# MANDATORY SERVICE BULLETIN

## NO. MSB-D4-053/2

Engine Controls - Electrical Harness  
ATA-Code: 76

## WI-MSB-D4-053

#### III.1 Instructions up to and including S/N D4.110, without G1000, without MÄM 40-151 and without DAI SBD4-036/1 implemented

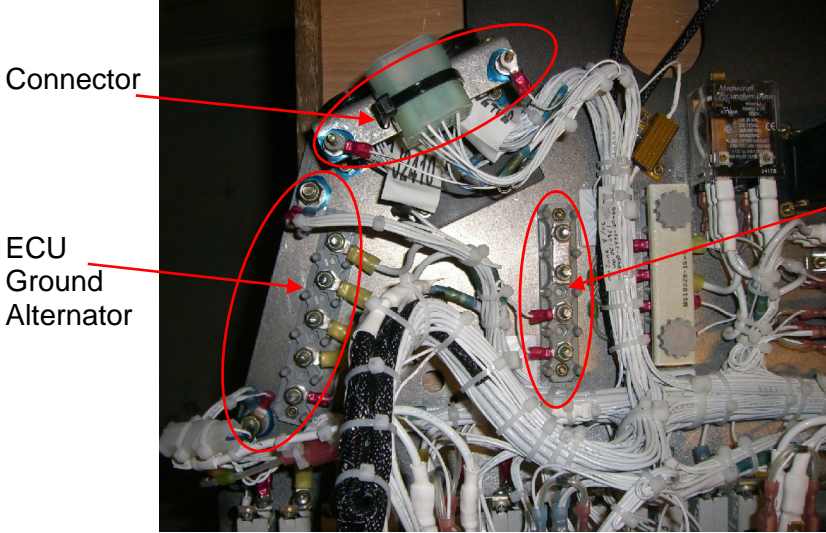
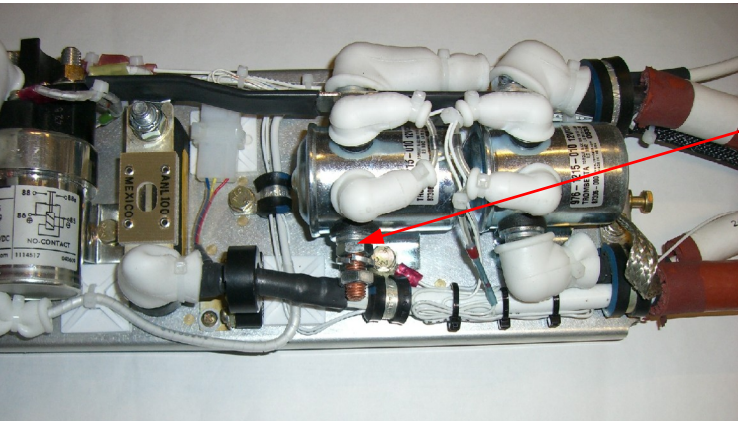
1	Remove the Engine Control System Harness in accordance with the Airplane Maintenance Manual, Doc. No. 6.02.01.
2	Modify the new engine harness according to drawing D4D-2406-32-00, if necessary.
3	<p>Install the new alternator regulator under the pilot's seat, as shown on drawing D4D-2433-01-00 and on the picture.</p> 
4	Replace the adapter in the instrument panel of the "old" Thielert engine harness, as shown in the attached sketch.
5	Modify the alternator regulator harness in accordance with D4D-2406-31-00, if necessary.
6	Connect the alternator regulator harness to the regulator, to the terminal block on the left, bottom side of the instrument panel and insert the wire for the alternator warning light into the new connector, Pin 7 of the engine harness previously modified in step 2.

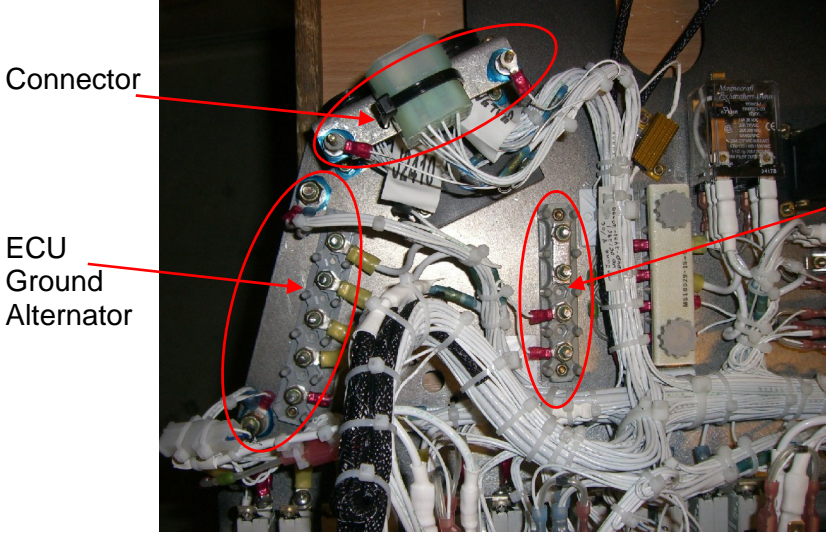
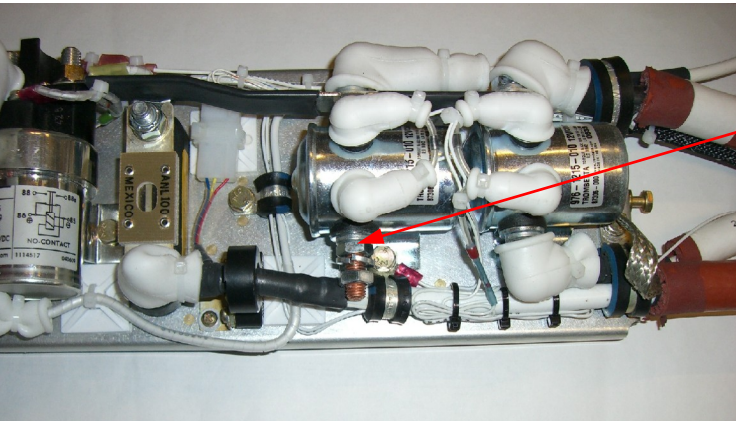
<p>7</p>	<p>Connect the new Thielert engine harness to its terminal blocks, connectors and shield connections. Refer also to the attached sketch.</p>  <p>Connector</p> <p>ECU Ground Alternator</p> <p>Glow</p> <p>CAUTION: Take extreme care of the polarity of the glow control connections and the diode, installed at the Glow Relay. Wrong connection (short circuit over the diode) will lead to a failure of the glow control output of the ECU and this will cause a replacement of the defective ECU.</p> <p>NOTE: If the actual installation looks slightly different, refer to the wire numbers for correct connection.</p>
<p>8</p>	<p>Connect the new GPC Loom V1.0, P/N 02-7150-55007R2 to the Glow Relay in the forward relay panel as shown below.</p>  <p>GPC Loom V1.0  P/N 02-7150-55007R2</p>
<p>9</p>	<p>Secure the harnesses by using appropriate cable ties, clamps and appropriate abrasion protection.</p>
<p>10</p>	<p>Clean working area and check for foreign objects.</p>

**III.2 Instructions above S/N D4.111, without G1000, without MÄM 40-151 and without DAI SB D4-036/1 implemented****NOTE**

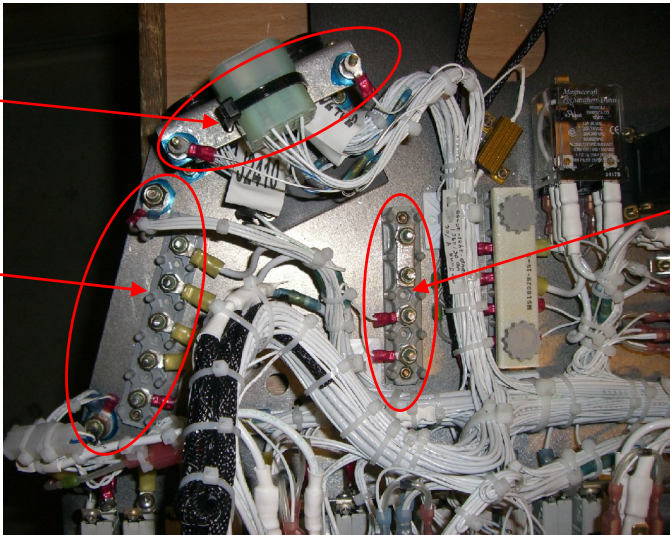
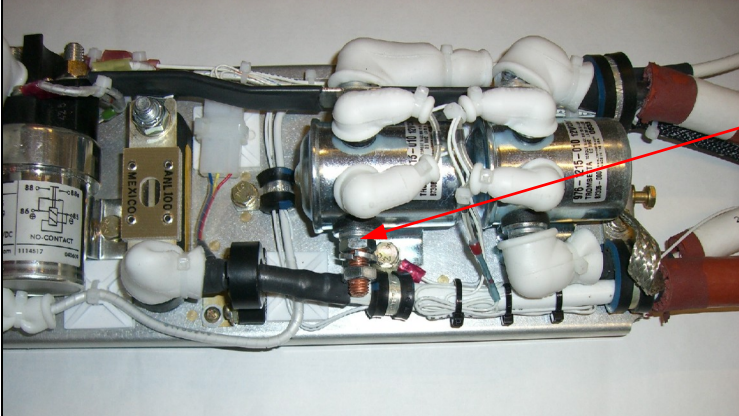
1	Remove the Engine Control System Harness in accordance with the Airplane Maintenance Manual, Doc. No. 6.02.01.
2	Modify the new engine harness according to drawing D4D-2406-32-00, if necessary.
3	Install the new alternator regulator under the pilot's seat, as shown on drawing D4D-2433-01-00 and on the picture. 
4	Modify the alternator regulator harness in accordance with D4D-2406-31-00, if necessary.
5	Connect the alternator regulator harness to the regulator, to the terminal block on the left, bottom side of the instrument panel and insert the wire for the alternator warning light into the new connector, Pin 7 of the engine harness previously modified in step 2.

<p>6</p>	<p>Connect the new Thielert engine harness to its terminal blocks, connectors and shield connections. Refer also to the attached sketch.</p>  <p>Connector</p> <p>ECU Ground Alternator</p> <p>Glow</p> <p>CAUTION: Take extreme care of the polarity of the glow control connections and the diode, installed at the Glow Relay. Wrong connection (short circuit over the diode) will lead to a failure of the glow control output of the ECU and this will cause a replacement of the defective ECU.</p> <p>NOTE: If the actual installation looks slightly different, refer to the wire numbers for correct connection.</p>
<p>7</p>	<p>Connect the new GPC Loom V1.0, P/N 02-7150-55007R2 to the Glow Relay in the forward relay panel as shown below.</p>  <p>GPC Loom V1.0  P/N 02-7150-55007R2</p>
<p>8</p>	<p>Secure the harnesses by using appropriate cable ties, clamps and appropriate abrasion protection.</p>
<p>9</p>	<p>Clean working area and check for foreign objects.</p>

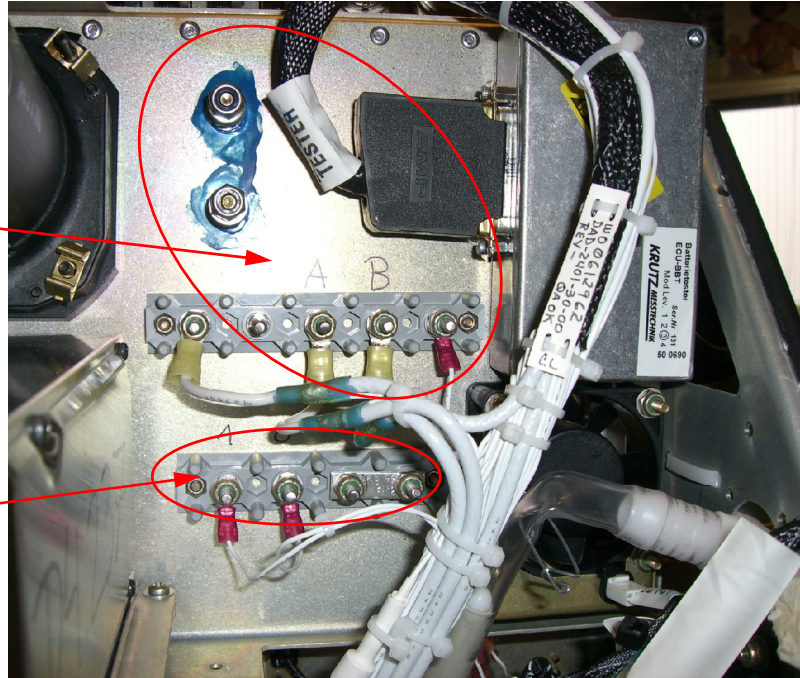
1	Remove the Engine Control System Harness in accordance with the Airplane Maintenance Manual, Doc. No. 6.02.01.
2	Modify the new engine harness according to drawing D4D-2406-32-00, if necessary.
3	Modify the alternator regulator harness in accordance with D4D-2406-31-00, if necessary.
4	Connect the alternator regulator harness to the regulator, to the terminal block on the left, bottom side of the instrument panel and insert the wire for the alternator warning light into the new connector, Pin 7 of the engine harness previously modified in step 2.
5	<p>Connect the new Thielert engine harness to its terminal blocks, connectors and shield connections. Refer also to the attached sketch.</p> <div style="text-align: center;">  </div> <p><b>CAUTION:</b> Take extreme care of the polarity of the glow control connections and the diode, installed at the Glow Relay. Wrong connection (short circuit over the diode) will lead to a failure of the glow control output of the ECU and this will cause a replacement of the defective ECU.</p> <p><b>NOTE:</b> If the actual installation looks slightly different, refer to the wire numbers for correct connection.</p>

6	<p>Connect the new GPC Loom V1.0, P/N 02-7150-55007R2 to the Glow Relay in the forward relay panel as shown below.</p>  <p>GPC Loom V1.0        P/N 02-7150-55007R2</p>
7	Secure the harnesses by using appropriate cable ties, clamps and appropriate abrasion protection.
8	Clean working area and check for foreign objects.
9	Install the Engine Control System Harness and the parts prior removed in accordance with the Airplane Maintenance Manual, Doc. No. 6.02.01.
10	Test all systems in working area for function.
11	Make all necessary entries in the airplane's logs

**III.4 Instructions above S/N D4.154, with G1000**

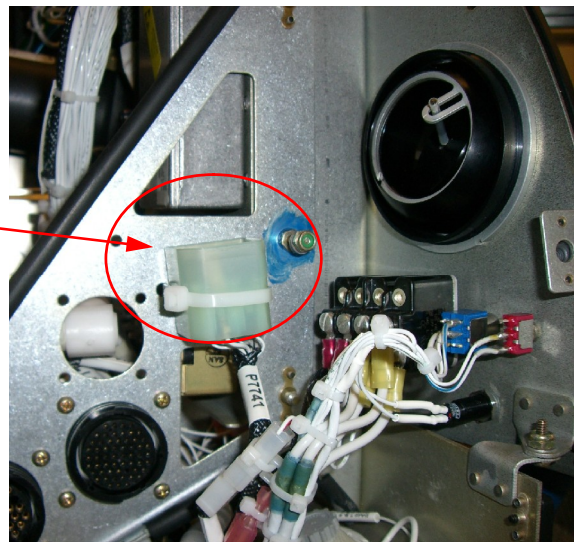
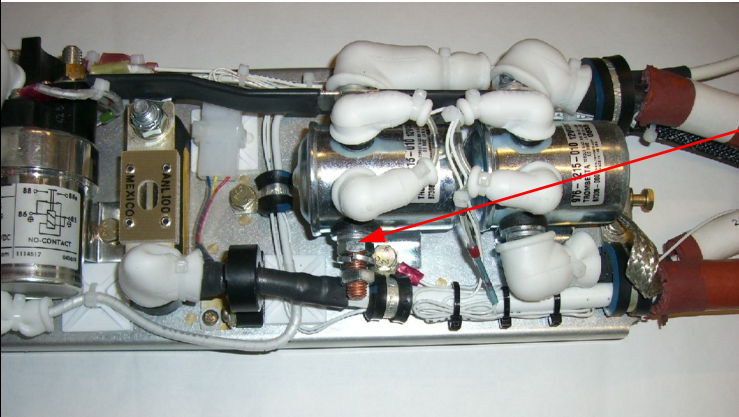
- 5 Connect the new Thielert engine harness to its terminal blocks, connectors and shield connections. Refer also to drawing D4D-3143-20-00.

**CAUTION:** Take extreme care of the polarity of the glow control connections and the diode, installed at the Glow Relay. Wrong connection (short circuit over the diode) will lead to a failure of the glow control output of the ECU and this will cause a replacement of the defective ECU.

**NOTE:** If the actual installation looks slightly different, refer to the wire numbers for correct connection.

<p>6</p>	<p>Connect the new GPC Loom V1.0, P/N 02-7150-55007R2 to the Glow Relay in the forward relay panel as shown below.</p>  <p>GPC Loom V1.0        P/N 02-7150-55007R2</p>
<p>7</p>	<p>Secure the harnesses by using appropriate cable ties, clamps and appropriate abrasion protection.</p>
<p>8</p>	<p>Clean working area and check for foreign objects.</p>
<p>9</p>	<p>Install the Engine Control System Harness and the parts prior removed in accordance with the Airplane Maintenance Manual, Doc. No. 6.02.01.</p>
<p>10</p>	<p>Test all systems in working area for function.</p>
<p>11</p>	<p>Make all necessary entries in the airplane's logs</p>
